March 2021  
 SF619A

**Subject: Cascadia Cummins Natural Gas Engine Exhaust Shield**

**Models Affected: Specific Model Year 2019-2021 Freightliner Cascadia model vehicles manufactured March 15, 2018, through October 16, 2020, and equipped with a Cummins natural gas engine.**

Fig. 1, Cab Mount Heat Shield Installation, RH

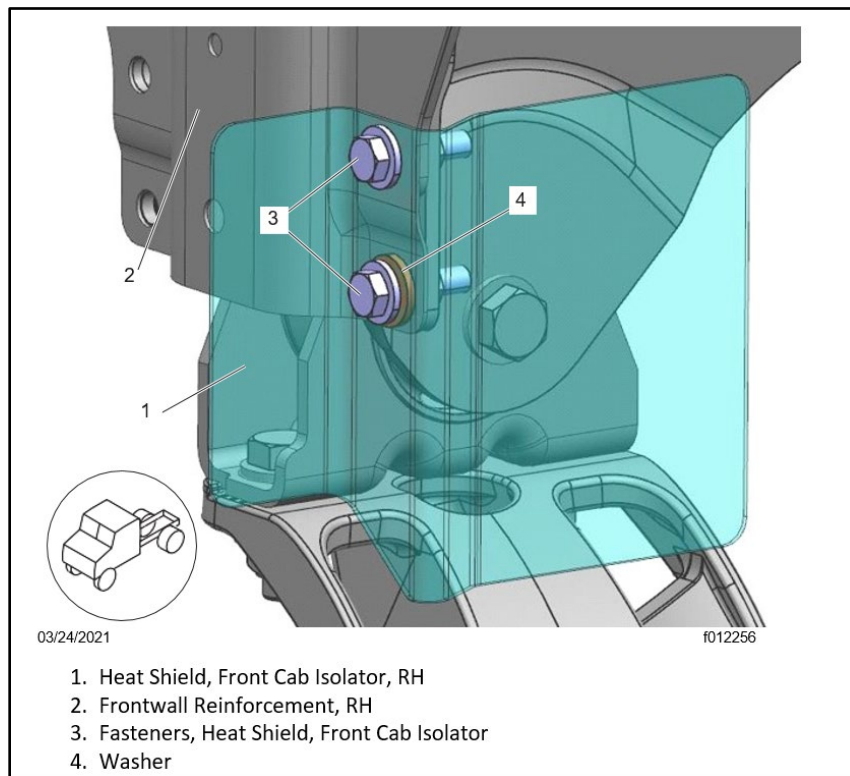
On certain vehicles, there may be early heat degradation at the front right cab mount due to excessive heat exposure.

An exhaust shield will be installed on all vehicles involved.

1. Inspect the base label (Form WAR259) for a completion sticker for SF619 (Form WAR260). If a sticker is present for SF619, no work is needed. If there is no sticker, proceed with the steps below.
2. Park the vehicle on a level surface, shut down the engine, and set the parking brake. Chock the tires.
3. Replace the front RH side cab mount isolator. For instructions, refer to **Section 60.01** of the *New Cascadia Workshop Manual*.
4. Position the heat shield (18-73852-000) on the RH side frontwall as shown in [Fig. 1](#).

5. Install the two fasteners that attach the heat shield to the front RH side frontwall, along with a washer on the lower fastener between the heat shield and the reinforcement. See [Fig. 1](#). Tighten the fasteners 34 lbf.ft (46 N.m).
6. Clean a spot on the base label (Form WAR259) and attach a campaign completion sticker for SF619 (Form WAR260), indicating this work has been completed.
